**CULTURAL RESOURCES OFFICE
 PRESERVATION BOARD
 REGULAR MEETING
 MONDAY JANUARY 28, 2013 — 4:00 P.M.
 1520 MARKET ST. #2000
www.stlouis-mo.gov/cultural-resources**

DATE: January 28, 2013
Address: 1824 Kennett Place
ITEM: Preliminary Review to restore a gate and install a decorative metal fence
JURISDICTION: Lafayette Square Certified Local Historic District — Ward 7
STAFF: Bob Bettis, Cultural Resources Office

DATE: January 28, 2013
SUBJECT: Appeal of Director's Denial to retain three (3) murals and four (4) awnings and to install an illuminated ground sign; deferred from November 2012 Preservation Board meeting
ADDRESS: 1218 S. Jefferson
JURISDICTION: Lafayette Square Local Historic District — Ward 6
STAFF: Andrea Gagen, Preservation Planner, Cultural Resources Office

DATE: January 28, 2013
ADDRESS: 2746 Utah Avenue
ITEM: Appeal of Demolition Permit Denial
JURISDICTION: Preservation Review District, National Register of Historic Place Historic District
— Ward 9
STAFF: Betsy Bradley, Director, Cultural Resources Office

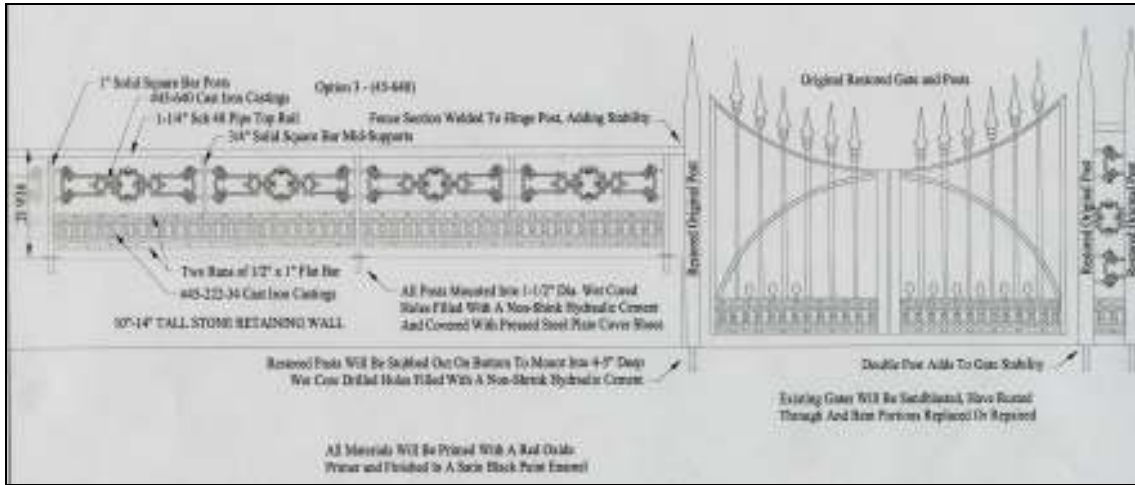
D] Street fences shall be metal and duplicate the proportion and scale of an HME. The HME fence shall be located in front of a building of similar age and type to the property under consideration.

The fence is the appropriate overall scale but, as the design is derived from stock elements rather than be based on an Historic Model Example and the use of the elements in a horizontal rather than traditional vertical orientation, the overall design has proportions that are not derived from an Historic Model Example.

Proposed Fence design

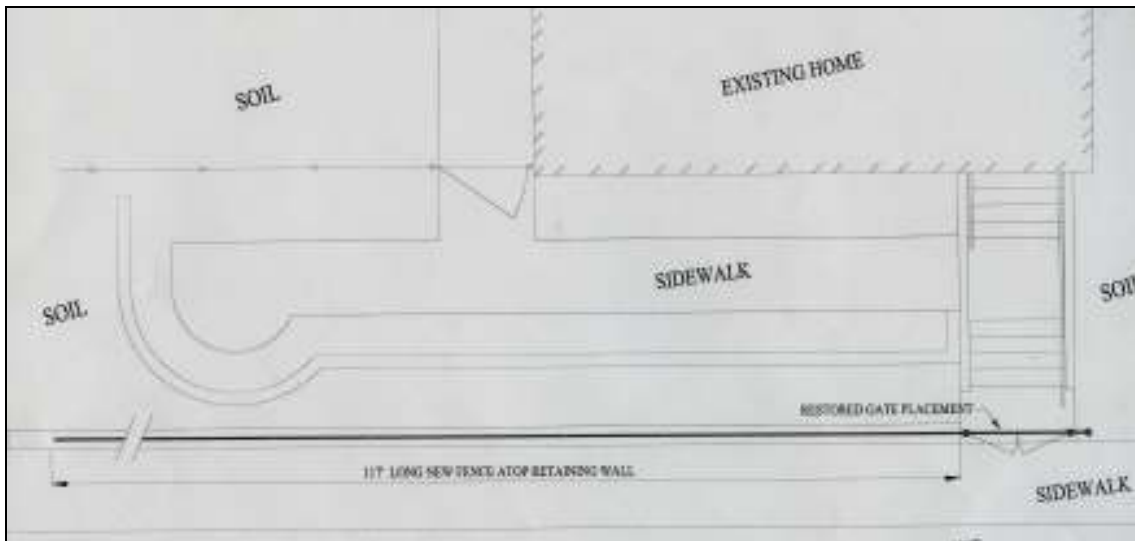
- That 1824 Kennett is located in the Lafayette Square Local Historic District and that the district standards include requirements for this type of element;
- That the original fence gate would be restored and that portion of the project meets the standards;
- That the proposed fence would not replicate the original and is not based on a Historic Model Example, as required by the standards;
- That the proposed fence would be built of stock elements;
- That the short run of fence between the gate and the west end post would also deviate from a Historic Model Example and the original fence; and
- That, for these reasons, the fence design would not meet the standards.

Based on the Preliminary findings, the Cultural Resources Office recommends that the Preservation Board deny the Preliminary Application of the proposed fence as it does not comply with the Lafayette Square Historic District Standards.

Awning and murals installed without a permit

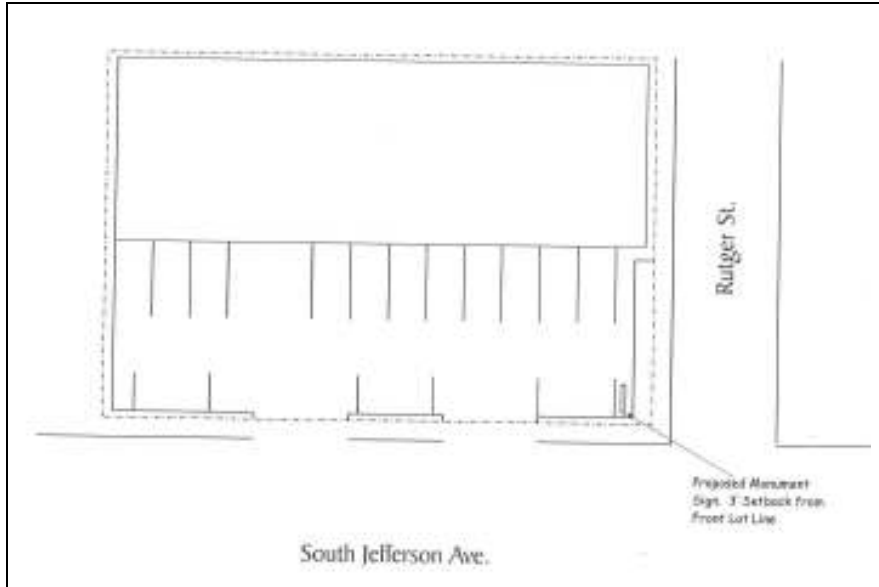
- 3) A 6-inch maximum height for lettering on the apron of an awning is permitted.**
Does not comply. Portions of the lettering on awning aprons appear to exceed 6 inches in height.

- 4) Placard signs shall be metal or painted wood, and shall not exceed 800 square inches in size.**
The murals on the Jefferson Street façade, which cover blocked-in windows, exceed the 800 square inches maximum for a placard sign, indicating that they are large features to be installed on the wall of the building.

- That 1218 S. Jefferson, is located in the Lafayette Square Local Historic District;
- The awnings, murals and some signage were installed without permits;
- The murals are not counter to the intent of the historic district standards;
- The lettering on the awnings exceeds 6 inches and is not consistent from awning to awning;

Based on the Preliminary findings, the Cultural Resources Office recommends that the Board overturn the denial of the application for the murals and awnings on the condition that an application be submitted that indicates that the lettering on the awnings aprons will be removed and none be applied or that the lettering would be replaced with letters no taller than 6 inches in height and limited to “**Quick Fix**” on one awning skirt and “**1218 S. Jefferson**” on one other awning skirt.
